ADDENDUM NO. CC-2

NORTHEAST COMMUNITY COLLEGE
HAIL DAMAGE ROOF REPAIR - BID SET TWO
801 East Benjamin Avenue
Norfolk, NE 68702-0469
BCDM Project No. 3500-12

BCDM Architects
1015 North 98th Street, Suite 300
Omaha, Nebraska 68114

07 October 2016

ATTACHMENT
ASD-01

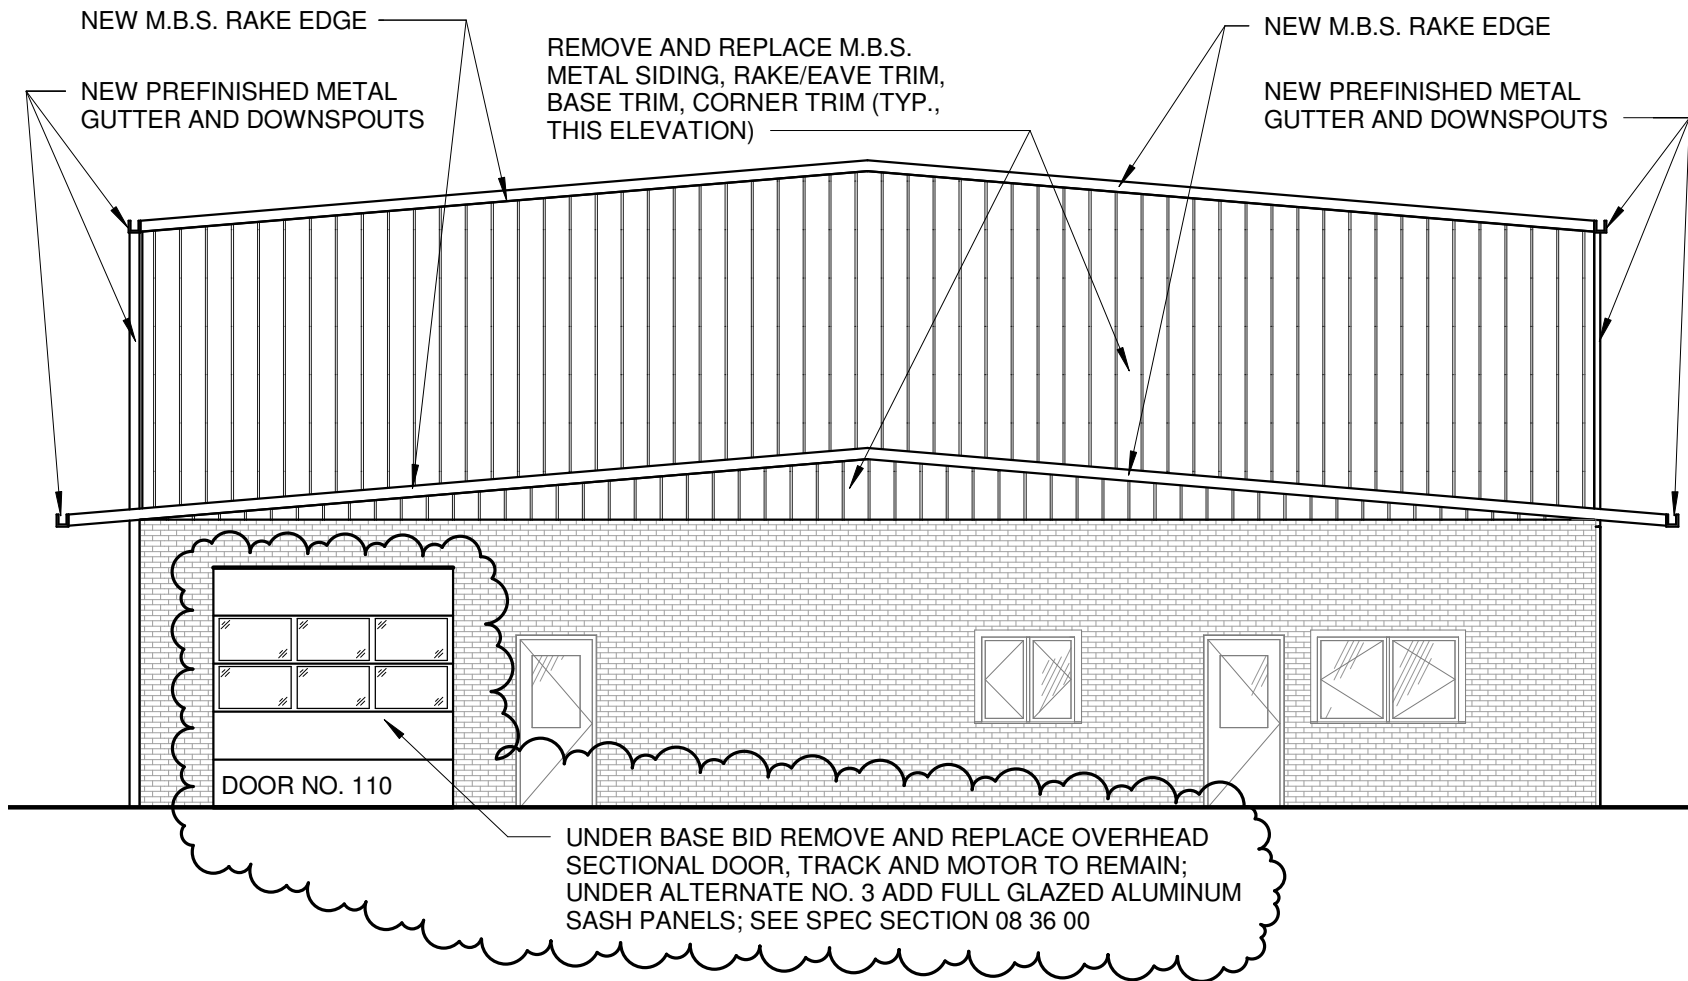
- a. At Reroofing Flag Notes, modify Flag Note No.4 to read, “Reinstall salvaged snow guards in same location”.
- b. At Detail 1 “Roof Plan”, modify snow guard layout on the south portion of the roof as shown on attached ASD-01.

3500-12	DRAWING REFERENCED: BC1-2	ATTACHMENT
10/07/2016		ASD-02

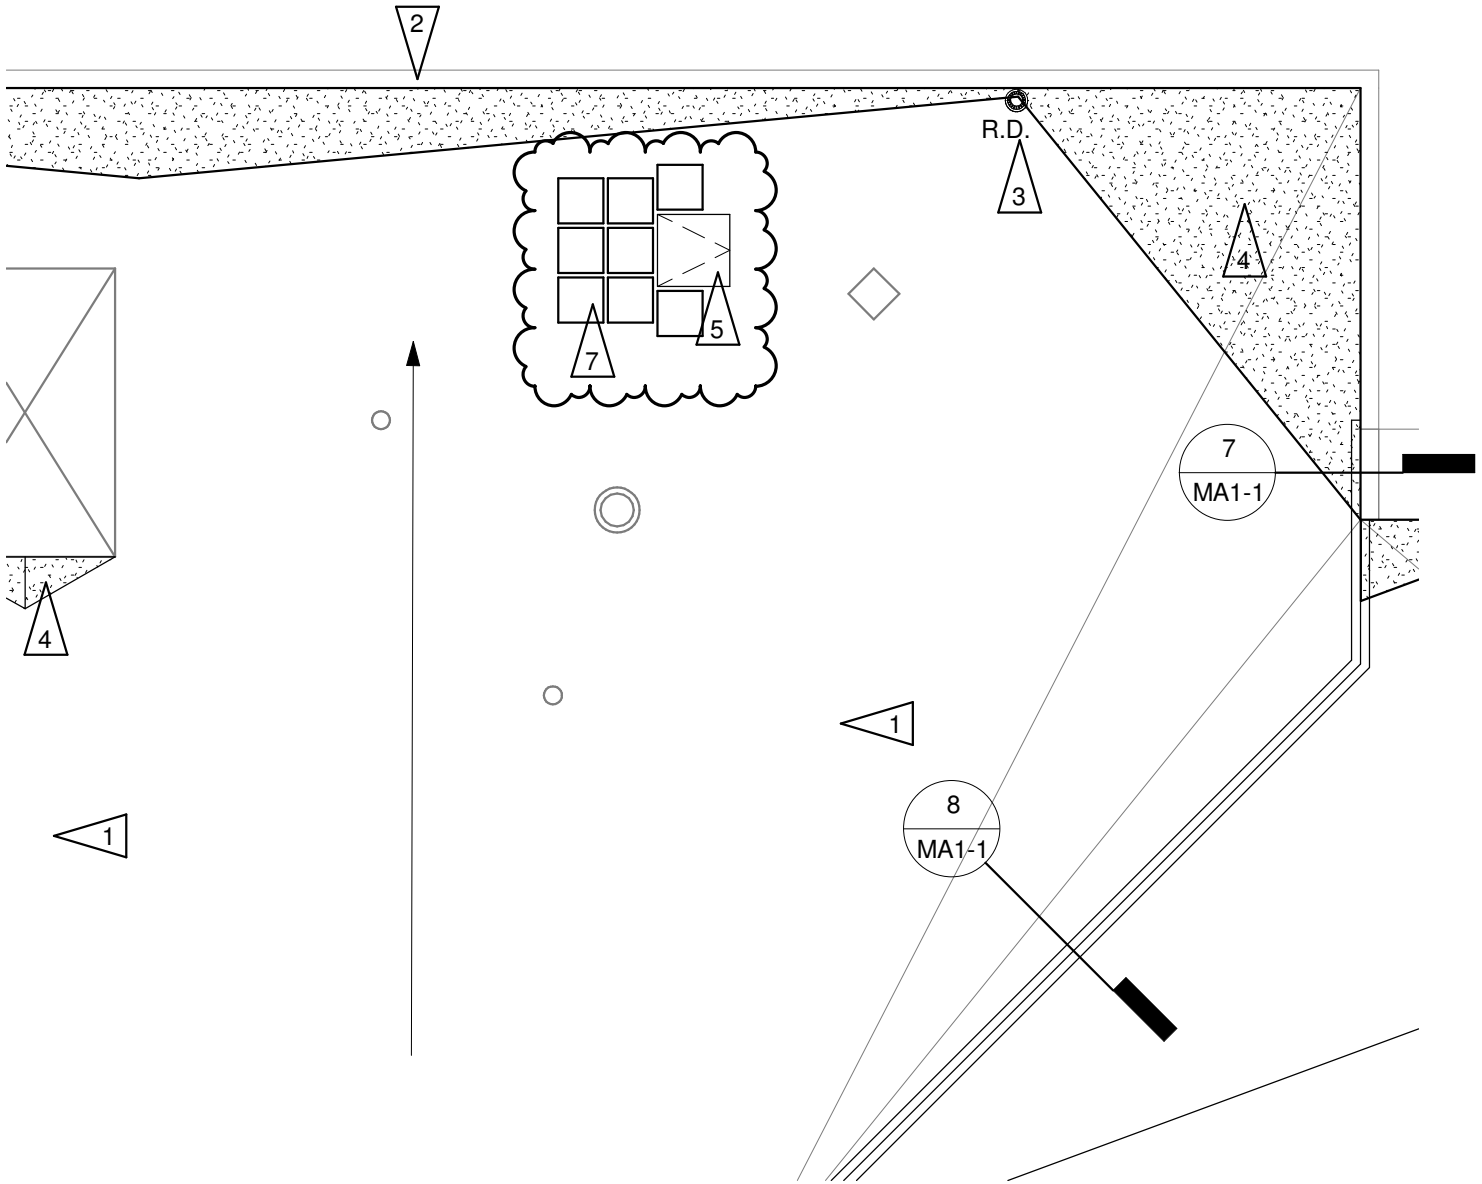
- a. At Reroofing Flag Notes, modify Flag Note No.1 to read, “Install new Metal Building System (M.B.S.) exposed fastening roof panels”.
- b. At Detail 5 “East Elevation”, modify overhead sectional door by naming it “Door No. 110” and adding the note “Under base bid remove and replace overhead sectional door, track and motor to remain; under Alternate No. 3 add full glazed aluminum sash panels; see spec section 08 36 00”, as shown on ASD-02.

3500-12	DRAWING REFERENCED: MA1-2	ATTACHMENT
10/07/2016		ASD-03

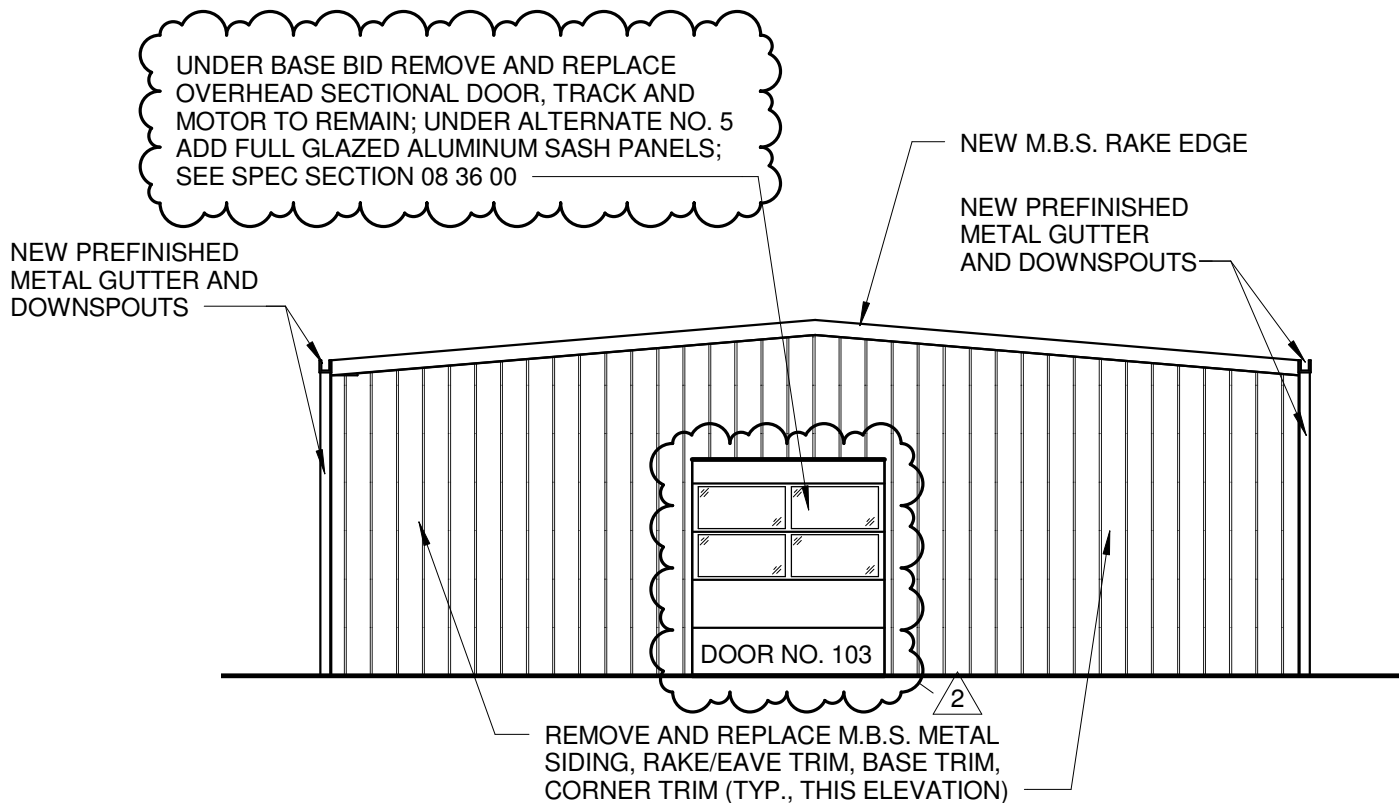
- a. At Detail 1 “Roof Plan”, modify the roof plan to add flag note 7 and walkway pads per ASD-03.
- b. At Reroofing Flag Notes, add Flag Note No. 7 to read “Provide 30x30 Walkway Pads as shown”.

3500-12	DRAWING REFERENCED: SU1-2	ATTACHMENT
10/07/2016		ASD-04

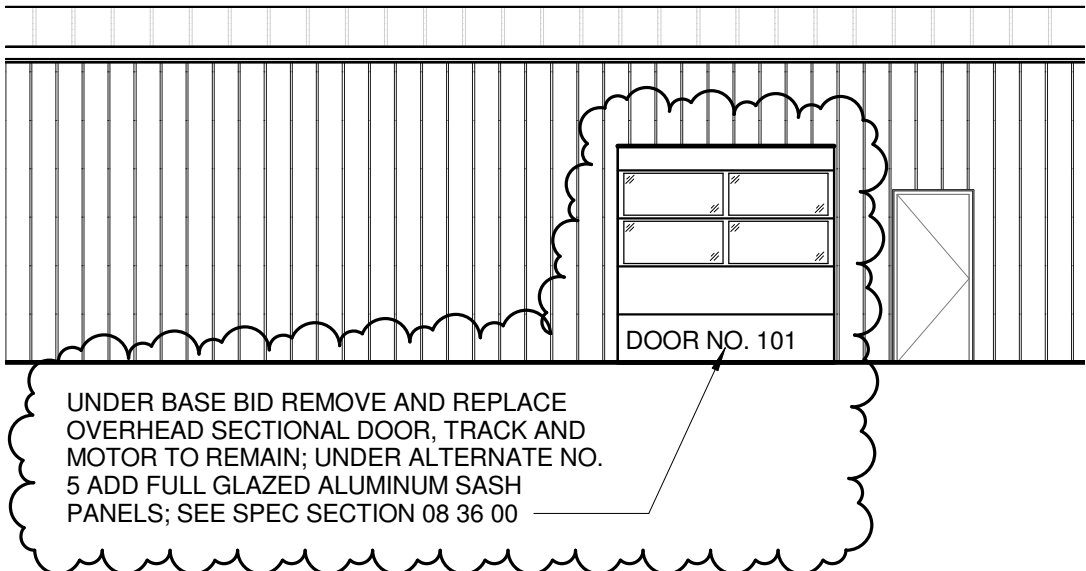
- a. At Reroofing Flag Notes, modify Flag Note No.1 to read, “Install new Metal Building System (M.B.S.) exposed fastening roof panels”.
- b. At Detail 2 “East Elevation”, modify overhead sectional door by naming it “Door No. 101” and adding the note “Under base bid remove and replace overhead sectional door, track and motor to remain; under Alternate No. 5 add full glazed aluminum sash panels; see spec section 08 36 00”, as shown on ASD-04.

- c. At Detail 3 “South Elevation”, modify overhead sectional door by naming it “Door No. 103” and adding the note “Under base bid remove and replace overhead sectional door, track and motor to remain; under Alternate No. 5 add full glazed aluminum sash panels; see spec section 08 36 00”, as shown on ASD-04.

3500-12	DRAWING REFERENCED: SU1-2	ATTACHMENT
10/07/2016		ASD-06

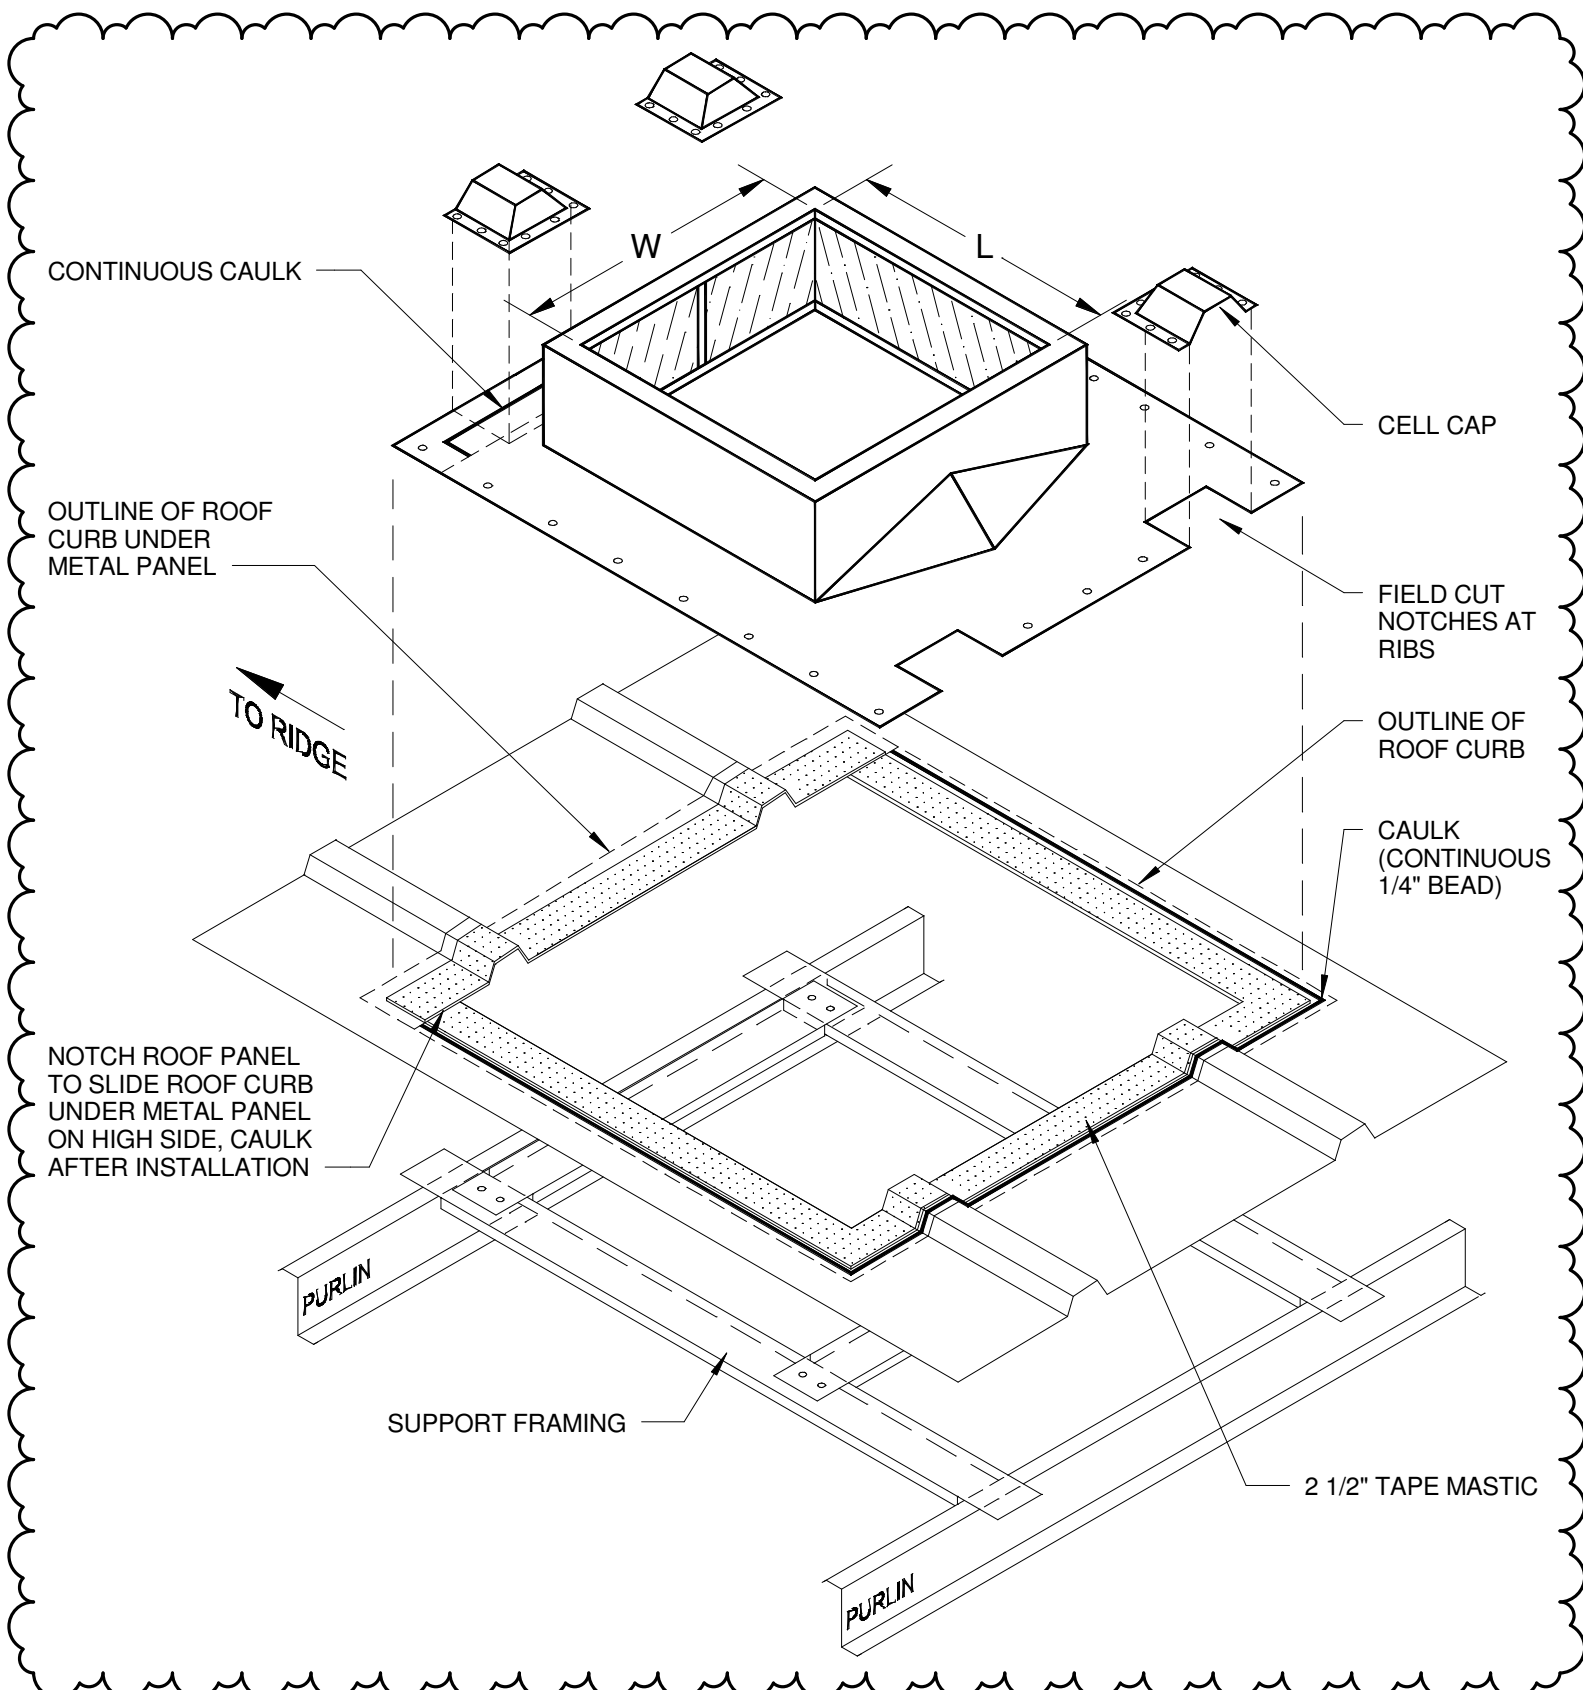
- d. Add “Door and Frame Schedule”, “Door, Frame and Glazing Remarks”, and “Door, Frame and Glazing Legend” as shown on ASD-05.
- e. Add Detail 6. “Door Type Elevations” to sheet SU1-2 as shown on ASD-06.

3500-12	DRAWING REFERENCED: AW1-2 & UL1-2	ATTACHMENT
10/07/2016		ASD-07

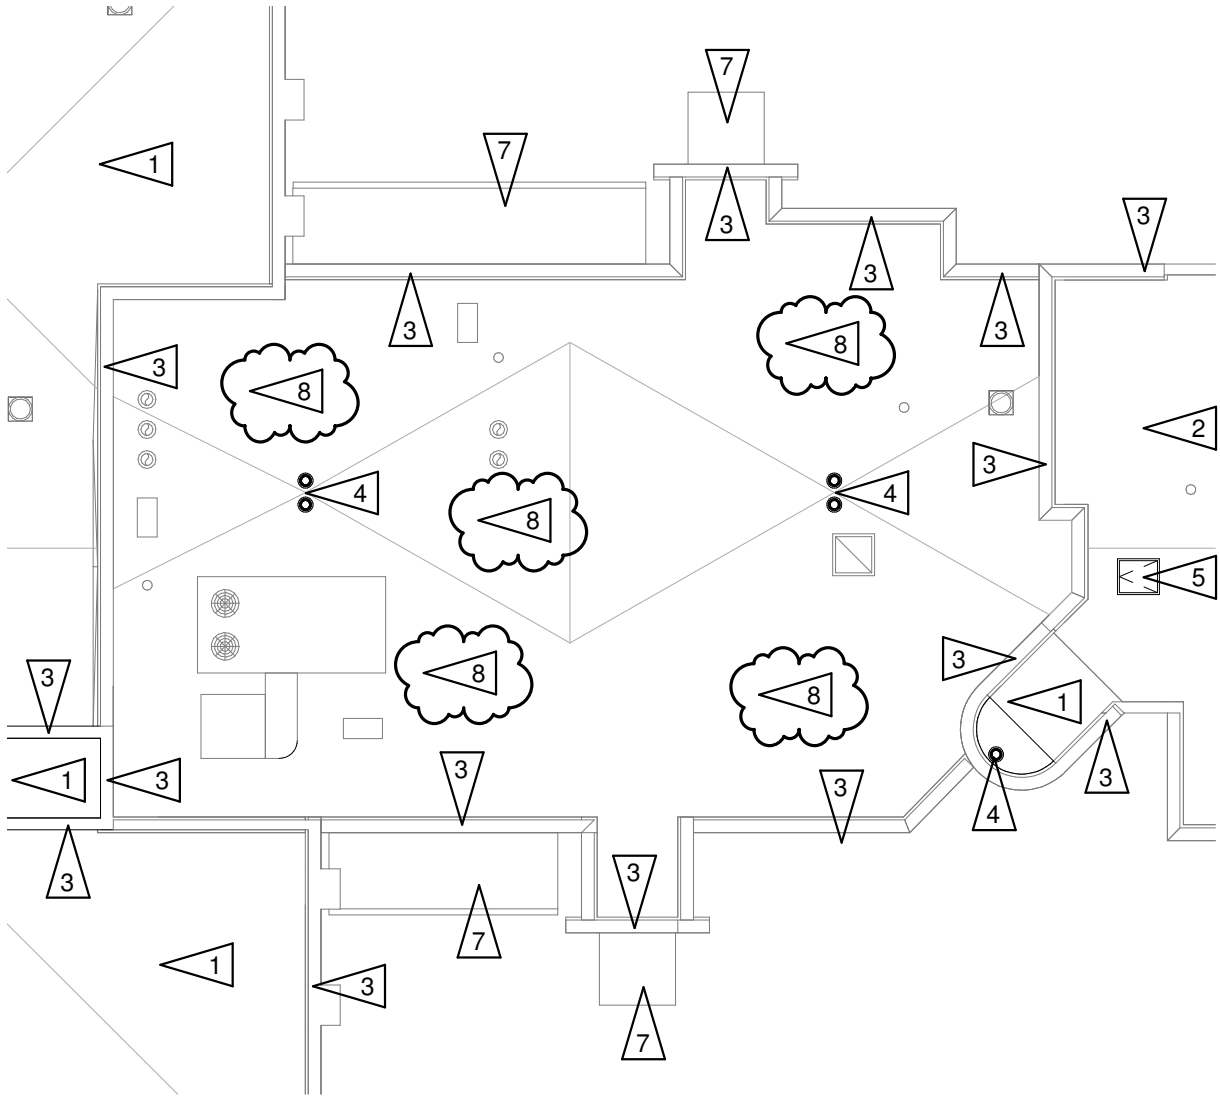
- b. Add Detail 2, “Typical Roof/Curb Flashing Detail” as shown on ASD-07, to sheet AW1-2.

- a. Add Detail 2, “Typical Roof/Curb Flashing Detail” as shown on ASD-07, to sheet UL1-2.
